Regulator Output Pressure Switch (P/N G11012)

This bulletin applies to all GPN2010, GPN2212, GPN2213 and GPN2214 panels with DE-3010 Terminal Module below serial number 1162 (panels shipped prior to January 16, 2008). This bulletin **DOES NOT APPLY TO** GPN1000 or any panel installed in a steel enclosure (GPN2000L, GPN2000V, GPN2002V, GPN2003V or GPN2004V).

Altronic-GTI is providing a new ROP SWITCH (P/N G11012) for all panels covered by this bulletin.

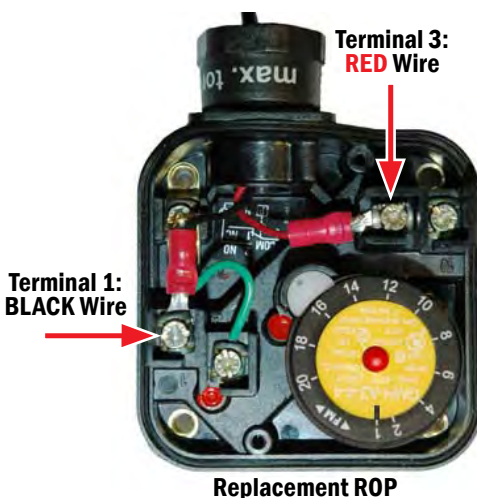
In order to ensure proper operation of the ROP (Regulator Output Pressure) switch, it is necessary to thoroughly and accurately carry out the following instructions to replace and test the switch.

1. Remove the plastic cover from the replacement ROP switch.
2. Remove the O-ring and mounting screws from the plastic bag inside the switch body. Place the O-ring over the gas pressure sensing port on the back of the switch.
3. Making sure that the O-ring remains in-place, mount the new ROP switch on the solenoid valve using the two mounting screws. It is critical that the sensing port of the ROP switch covers port 5 on the solenoid valve (refer to FORM GTI IOM 5-07). **FAILURE TO DO SO RENDERS THE SWITCH INEFFECTIVE.**
4. Run the **RED** and **BLACK** harness wires through the conduit gland of the switch body. Connect the **RED** wire to **TERMINAL 3** and the **BLACK** wire to **TERMINAL 1** as shown. Although this is reversed from the original installation, this will be the new wiring configuration on future systems.

SETTING THE ROP SWITCH

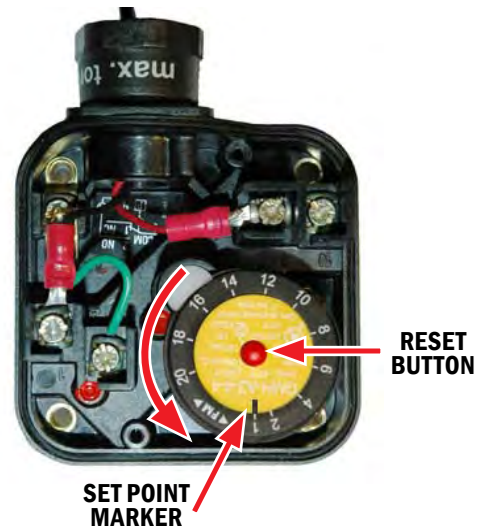
1. The **ROP** switch is shipped with the number **1** on the outer set point dial aligned with the **BLACK** mark on the inner stationary portion of the dial. Check that this is the alignment. If not, rotate the dial to align the **1** with the inner **BLACK** mark as shown.
2. Press the **RED** button in the center of the set point dial to ensure that the **ROP** switch is in the **RESET** position.

TESTING THE ROP SWITCH WIRING

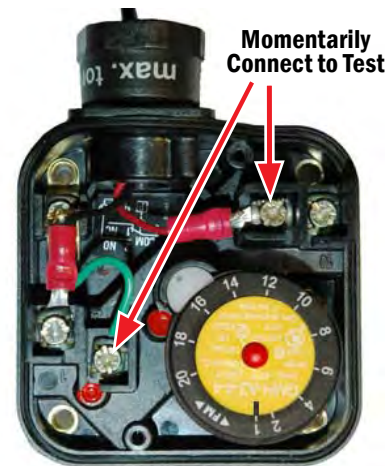
1. Turn the switch on the front of the **GTI** panel to the **ON** position.
2. Press the **RESET** button on the **Display Module** keypad followed by the **CANCEL TIMERS** button.
3. Using a small jumper wire or clip lead, momentarily make contact with **TERMINALS 2** and **3** as shown. This action will cause the **GTI Panel** to see the **ROP** switch as “tripped.” Proper operation is verified when the screen shows the **FAULT** as below:

If the switch does not trip, it indicates that the switch body is not achieving ground through the body of the gas train system to the engine block.

4. Once operation has been verified, press the **RESET** button on the **Display Module** keypad and reset the switch by pressing the **RED** button in the middle of the set point dial on the **ROP** switch.
5. Reinstall the plastic cover.
